Determination 2015/007

Regarding the authority's exercise of powers in refusing to issue a modification of clause G6 for an apartment block at 105-109 Apollo Drive, Rosedale, Auckland

SCHEMATIC SECTION THROUGH FOUR UNITS

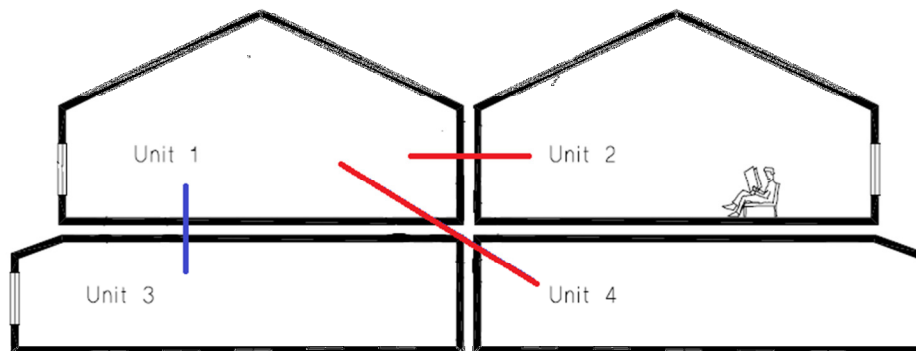
- 7.2 The performance requirement of G6.3.2 refers to the IIC of 'floors' which indicates G6.3.2 would only apply to floor-ceiling assemblies not horizontal floors. I note that at Figure 3 of the Acceptable Solution G6/AS1 only refers to floor-ceiling assemblies.
- 7.3 Additionally, the interpretation section A2 provides the following definitions for IIC. The IIC specifically refers to floor-ceiling assemblies:

- 7.4 The testing of ASTM E 492 is therefore restricted to floor-ceiling arrangements. Additionally I acknowledge the comments from the authority's acoustic engineer that there is currently no known acoustic laboratories world-wide where any horizontal impact testing has been carried out on concrete structures.
- 7.5 In relation to the diagonal application, I do not consider there is a building element that is common between the occupancies of Unit 1 and Unit 4 of Figure 1. I do not consider the units are abutting.

7.6 Therefore, I am of the opinion that G6.3.2 applies to vertical assemblies only (refer blue line of Figure 1) and does not apply to horizontal assemblies (refer red lines Figure 1).
